Pre-Filed Testimony of K.M. Leytham

**Submitted on behalf of Appellant
Airport Communities Coalition**

**PCHB No. 01-160
*ACC & CASE v. Dept. of Ecology & Port of Seattle***

February 22, 2002

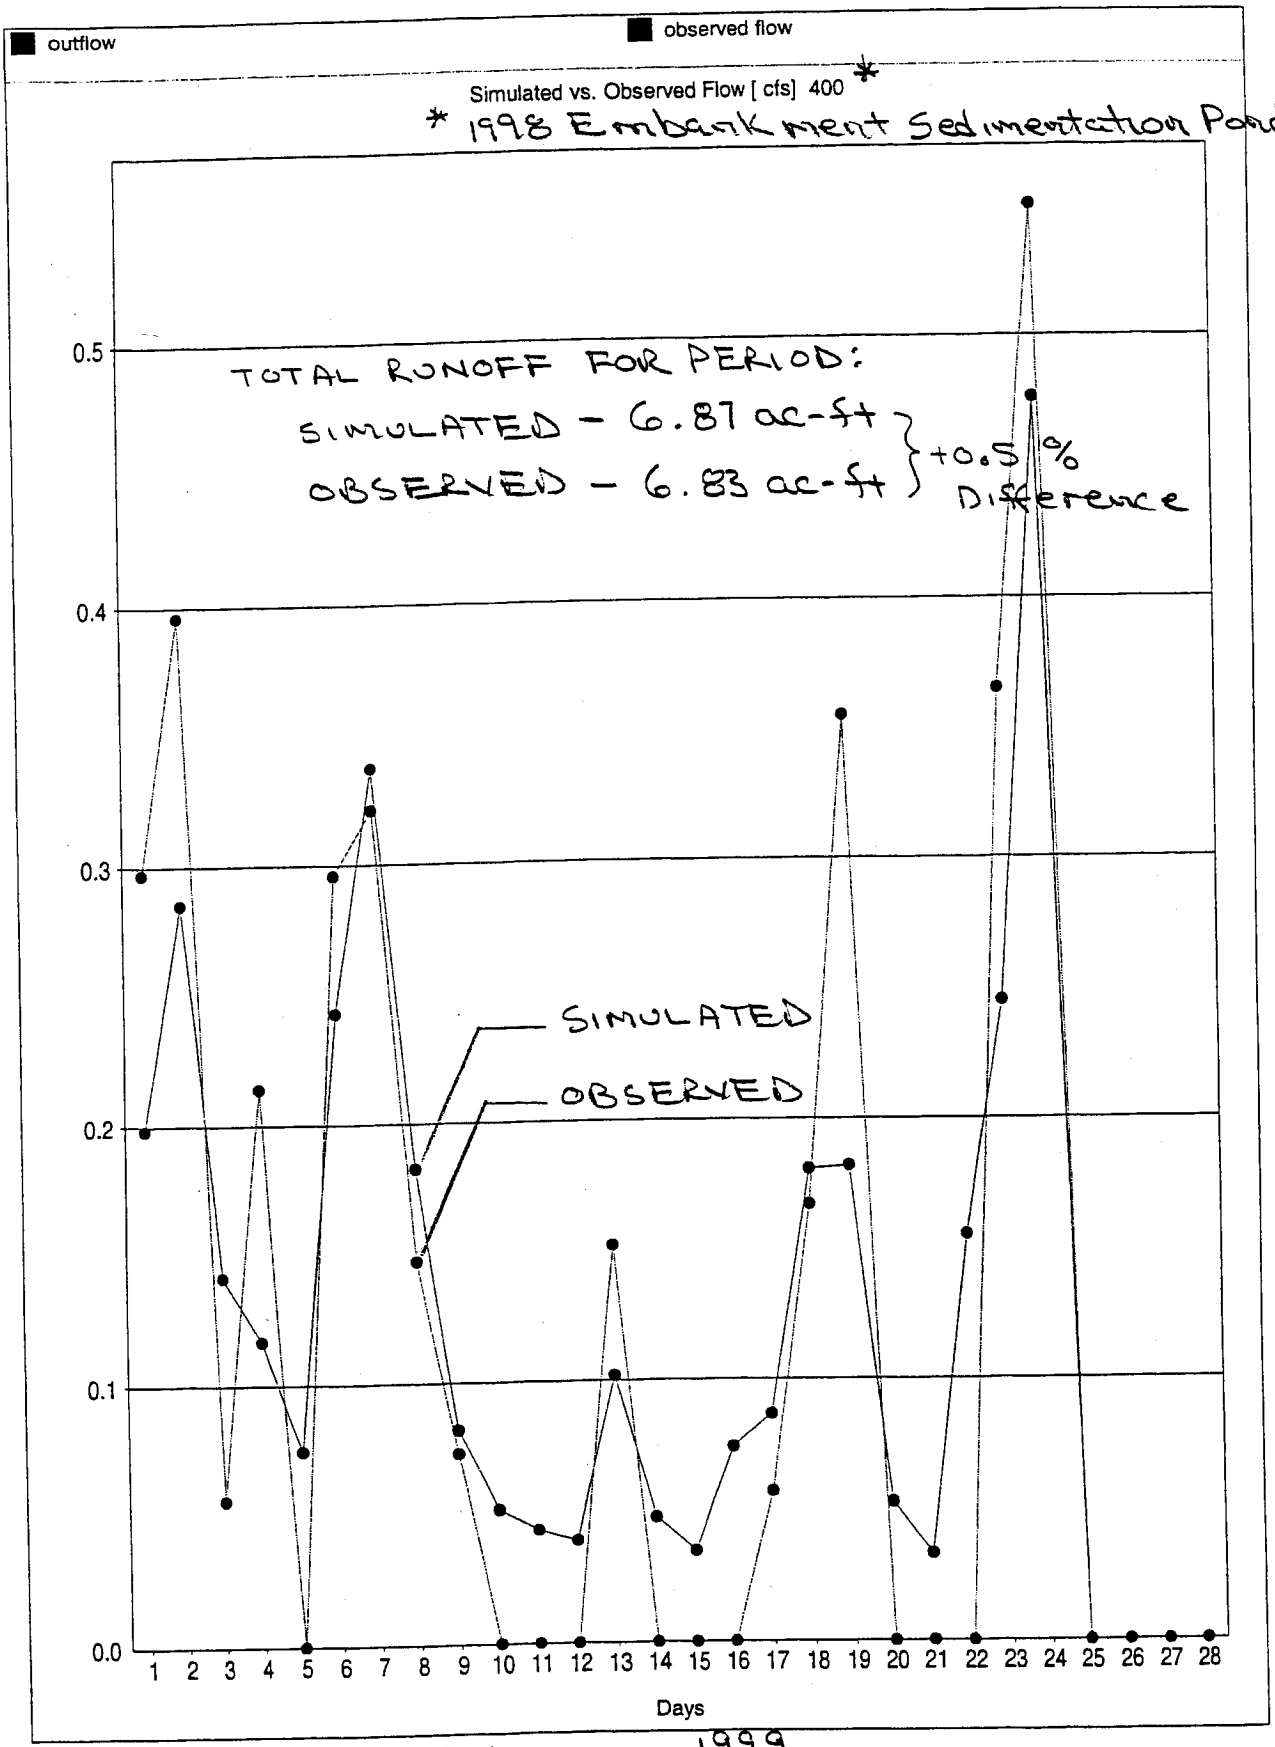
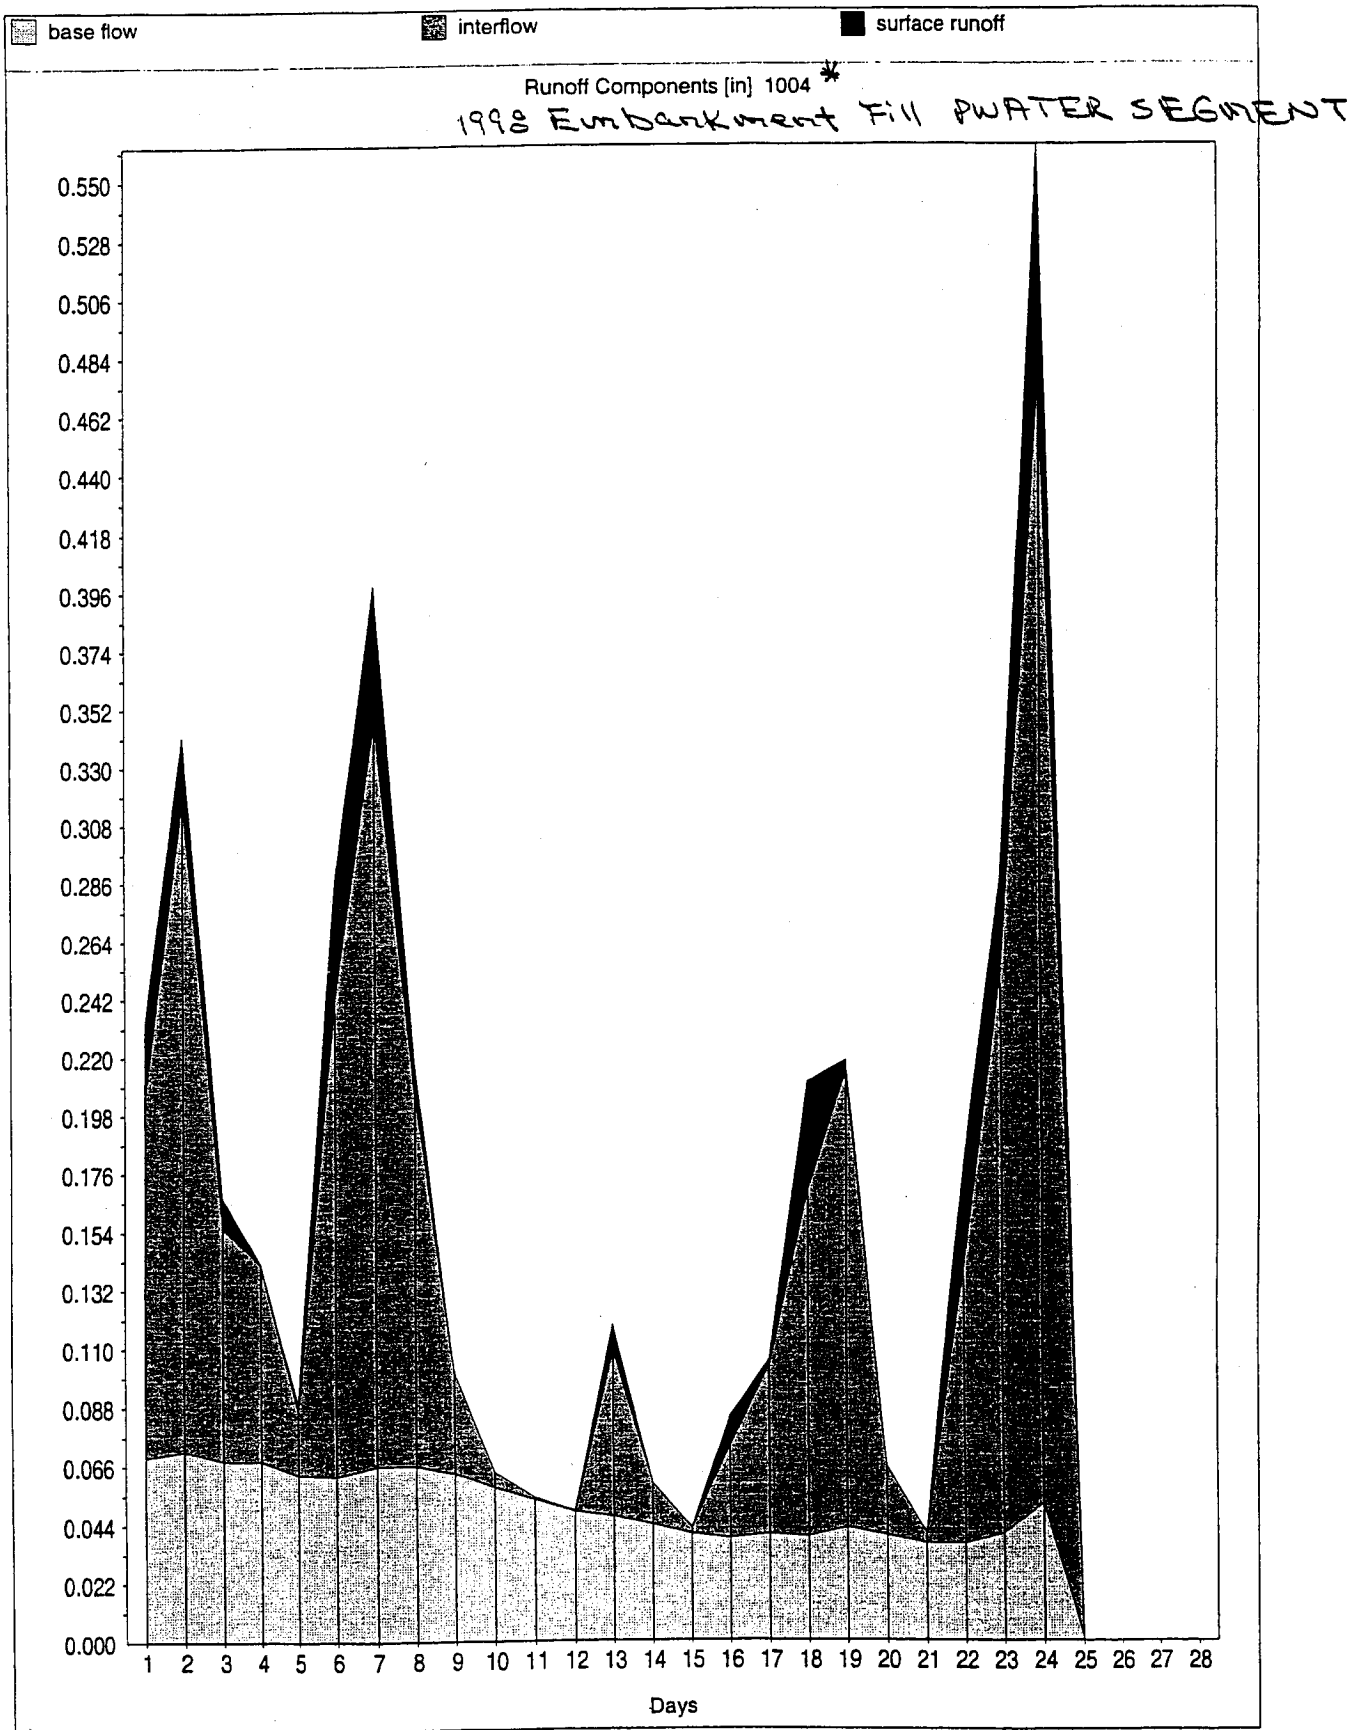
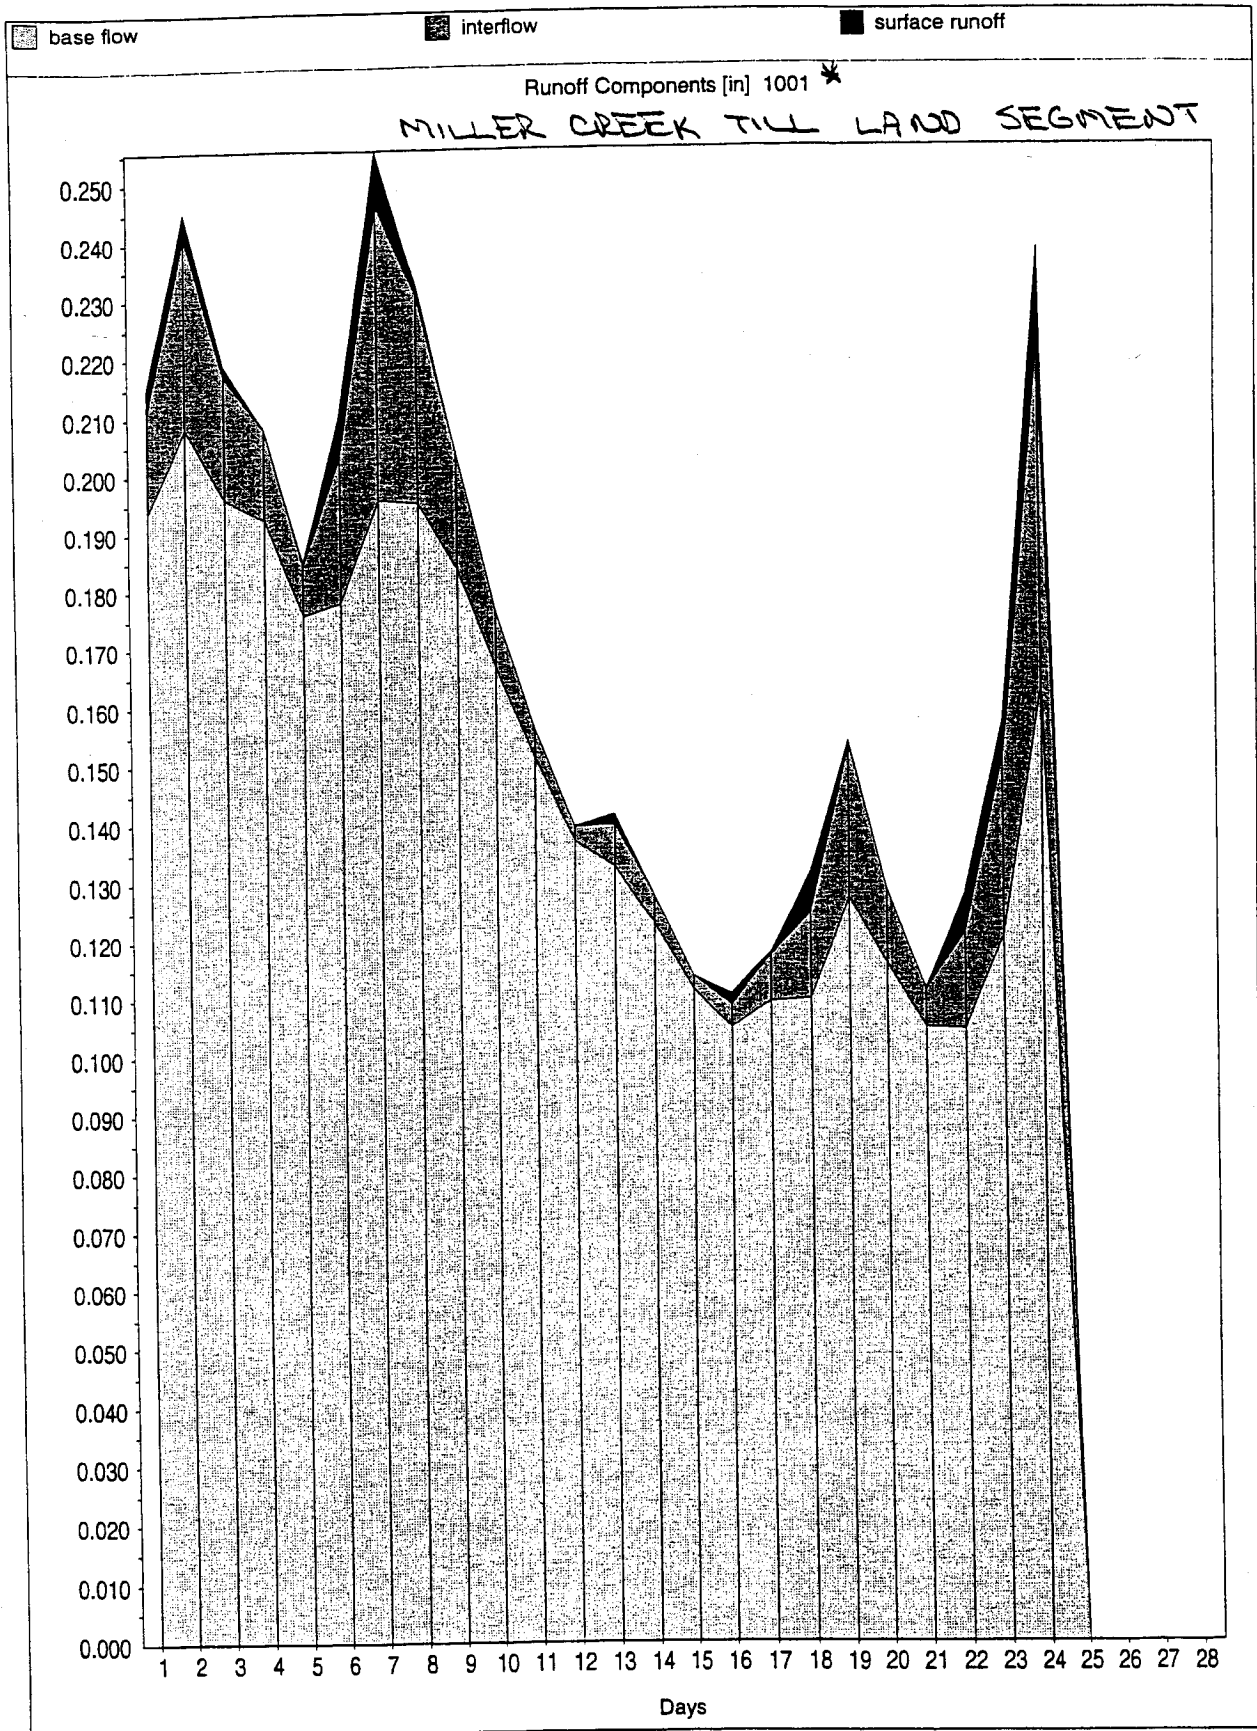
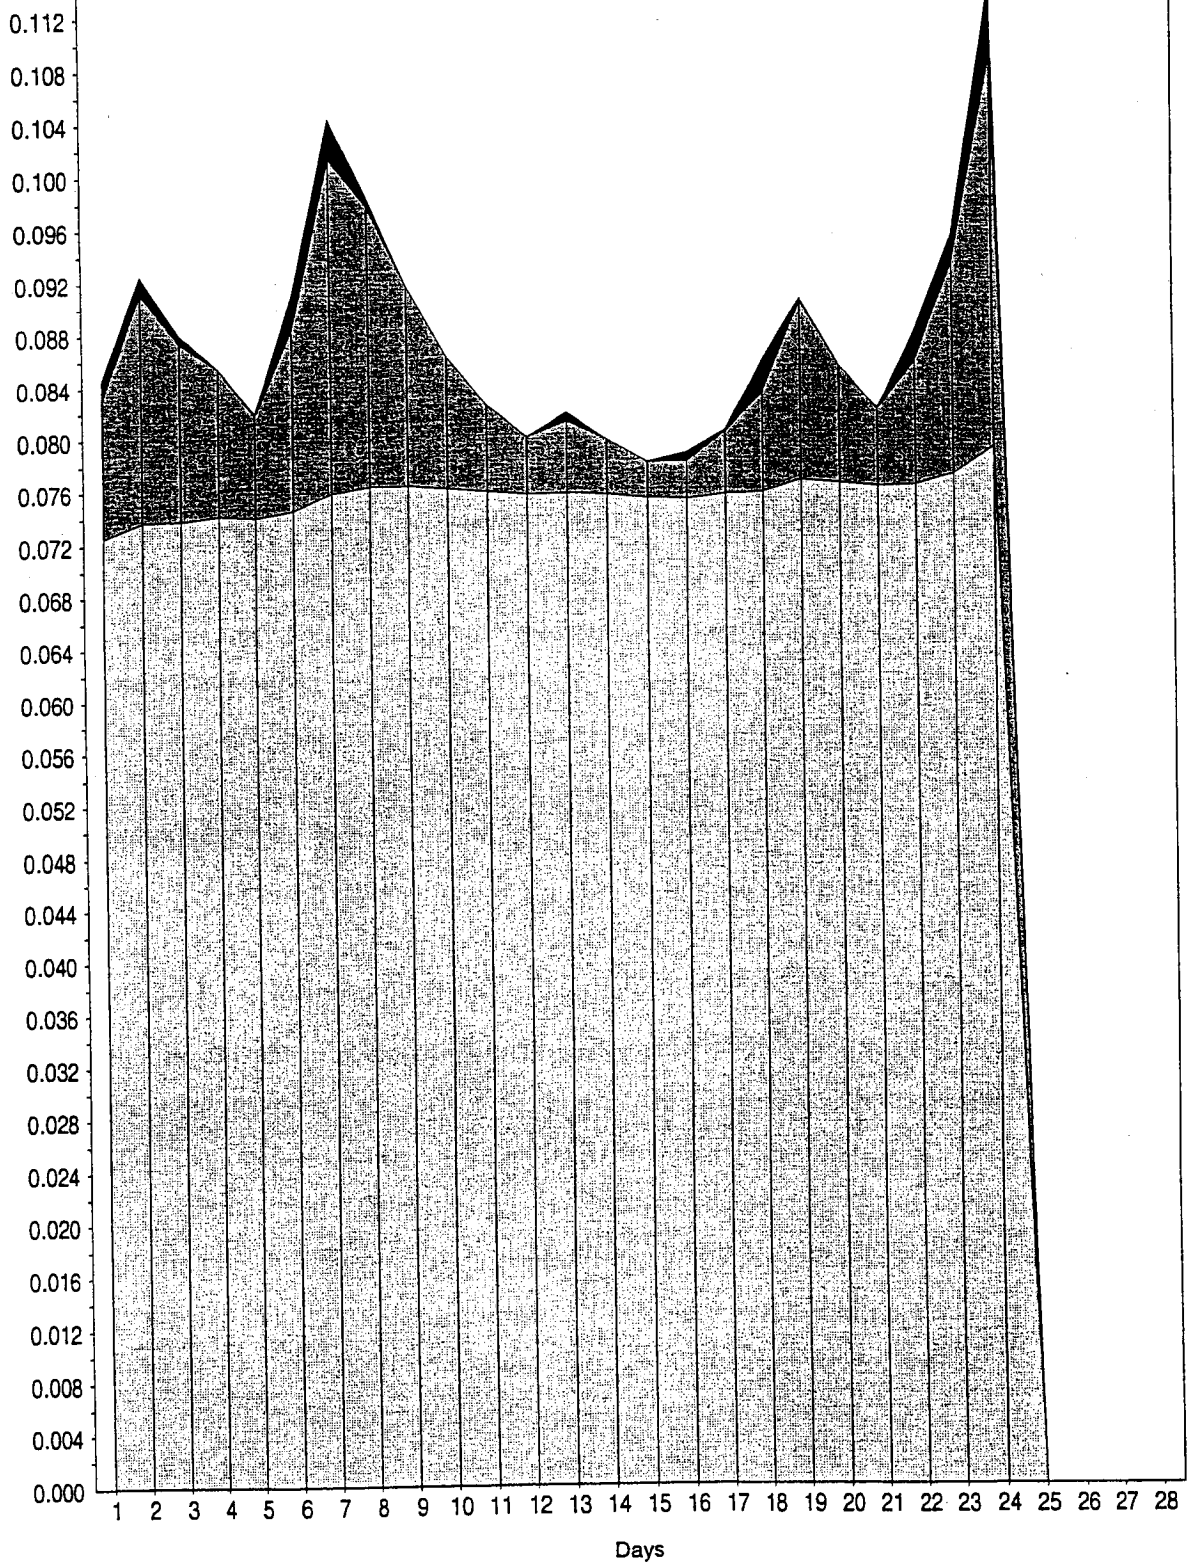
25. In order to characterize the hydrology of the proposed fill embankment, HPSF was calibrated against one month of observed runoff data (from February 1999) from a 19.4-acre area of the 1998 embankment site. The calibration results are presented in Appendix A of the SMP. The observed runoff from the embankment is flashy with high peaks and low base flow indicating low infiltration rates and significant amounts of surface runoff. The resultant HSPF model parameters show a hydrologic response similar to that of native till soils. Key HSPF model parameters for the embankment fill are summarized in Paragraph 28 below. Model simulation results, shown in **Exhibit H**, are adequate given the short period of observed data but tend to understate peak flows and overstate base flows. The period for which observed data are available was reasonably wet with total rainfall over the month of February 1999 of 6.95 inches and 1.04 in the wettest 24-hour period. By way of comparison the 2-year 24-hour rainfall for SeaTac Airport is approximately 2.0 inches. A longer period of observed runoff data from the embankment fill is needed to provide better confidence in model results.
